Access Compliance Report

Public Rights-of-Way

(Curb Ramps)

Intersection ID: 12504	Main Street: N_BREVARD_ST	Cross Street: E_5TH_ST	Location: N
ADA ID: F0FE7C344A60	Ramp Type: Perp	Initial Pass/Fail: Pass	Overall Compliance: No
Severity Score: 0.25			
Codes/Mitigation Info/Possible Solution		Field Measurements/Component Compliance

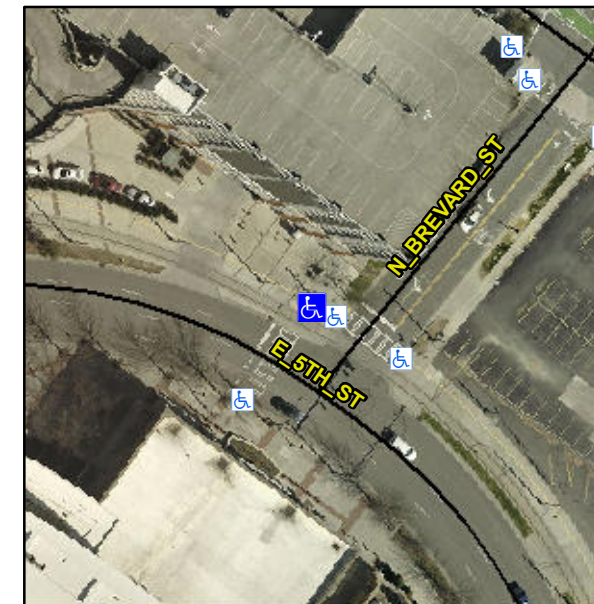
R304.5.3

Compliance	Description	Data	Compliance	Description	Data
N/A	Ramp Length (in)	120.0	Yes	Ramp Slope (%)	6.0
Yes	Ramp Width (in)	120.0	No	Ramp XSlope (%)	4.2
N/A	Flare Type LT	Sloped	N/A	Flare Type RT	N/A
N/A	Flare Slope LT (%)	3.8	Yes	Flare Slope RT (%)	0.8
N/A	Flare Traversable LT?	Yes	N/A	Flare Traversable RT?	Yes
Yes	Landing Length (in)	48.0	Yes	DWS Provided?	Yes
Yes	Landing Width (in)	48.0	Yes	DWS Contrast?	Yes
Yes	Landing Slope (%)	0.8	Yes	DWS Length (in)	24.0
No	Landing X Slope (%)	2.6	Yes	DWS Full Width?	Yes
N/A	Landing Curb? (Y/N)	No	Yes	DWS Offset (in)	0.0
N/A	Shared Landing?	No			
Yes	Gutter Ponding?	No	Yes	Gutter Slope (%)	0.8
Yes	Gutter Lip Ht (in)	0.0	Yes	Gutter X Slope (%)	1.6
N/A	Painted X Walk1?	Yes	N/A	Painted X Walk2?	N/A
	X Walk 1 Direction	To SW		X Walk 2 Direction	N/A
N/A	X Walk 1 Width (in)	104.0	N/A	X Walk 2 Width (in)	N/A
	X Walk 1 Slope (%)	2.7		X Walk 2 Slope (%)	N/A
	X Walk 1 X Slope (%)	1.4		X Walk 2 X Slope (%)	N/A

Remove & Replace Entire Ramp.
